Liberty 2025 Wildfire Mitigation Plan Update

OEIS Docket Name: 2023 to 2025 Electrical Corporation Wildfire Mitigation Plans
OEIS Docket Number: #2023-2025-WMPs

Figure 5-1: Liberty High Level Risk-Based Decision-Making Framework Process

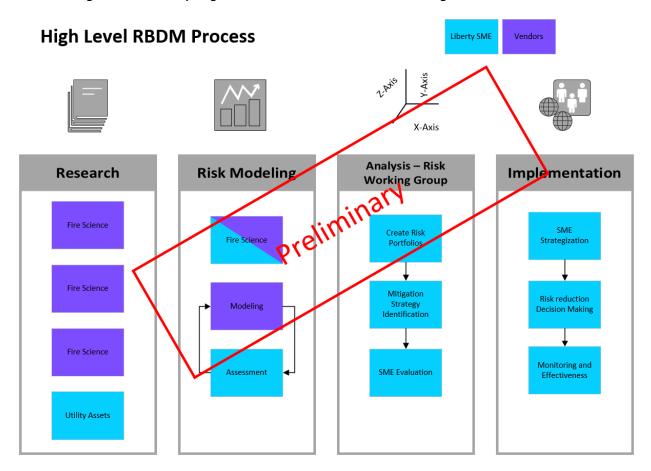
- Demonstrate how Liberty differentiates between activities completed by the internal staff and vendor staff throughout risk modeling narratives. This includes processes, procedures, methodologies, flow charts, schematics, and any explanations that describe collaboration with a risk modeling vendor.
- Demonstrate how Liberty identifies activities that require vendor discretion and state whether final approval from the Liberty risk team is required. This includes any decisions that need to be made, such as mitigation selection.
- Indicate the source of the data where a description of data is required, specifically indicating whether the data are internally generated or vendor generated. If Liberty cannot indicate the source of the data, it must explain why.

Liberty Response: Liberty collaborates with vendors to develop its overall risk models and relies on vendors to provide a platform for running simulations and analyzing different scenarios. Liberty is responsible for producing simulations, analysis, and resulting mitigation decision-making.

Liberty describes the data sources used for the wildfire risk model in Section 6.5 and its risk modeling approach in Section 7.1 of its updated 2023-2025 WMP. Refer to Figure 5-1 for a high level summary of how Liberty's SMEs and Liberty's risk model vendors will share risk modeling and mitigation related duties.

Figure 5-5: Liberty Findings from Detailed Asset Inspections

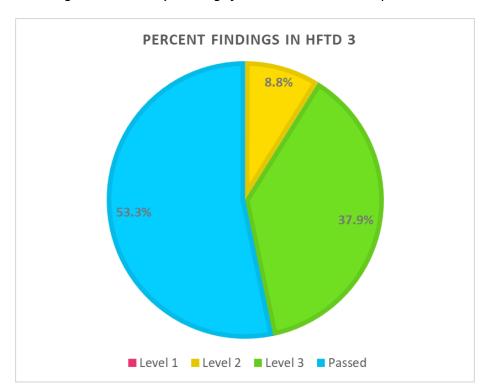
- Outline a plan to update its detailed inspections in higher risk areas, including:
 - An analysis for determining the updated frequency for performing detailed inspections.
 - Prioritization of higher risk areas based on risk analysis and risk model output, including HFTD Tier 3 lands.
 - Updates to inspection checklists to account for equipment or configurations that may pose greater wildfire risk.
 - A plan to obtain any needed workforce for performing more frequent inspections; OR
- Demonstrate that its existing inspection program adequately addresses risk. This must include analysis of the following:
 - o Number of Level 1 or critical issues found during detailed inspections.

Liberty Response: Liberty's existing program adequately addresses risk and would not significantly reduce risk by increasing inspection frequency. An analysis of 2,290 detailed inspection records in Liberty's database show that 0.04% of inspections in HFTD Tier 3 resulted in a Level 1 issue found. When examining non-critical issues, 53.28% inspections were passed, and 37.86% Level 3 issues were found. This equates to 91.14% of inspections being no or low risk findings in HFTD Tier 3 lands. The remaining 8.82% of inspections resulted in a Level 2 finding, which Liberty follows the corrective action timeline established in General Order 95, Rule 18 of six months to address the risk. Refer to Table 5-2 and Figure 5-5.
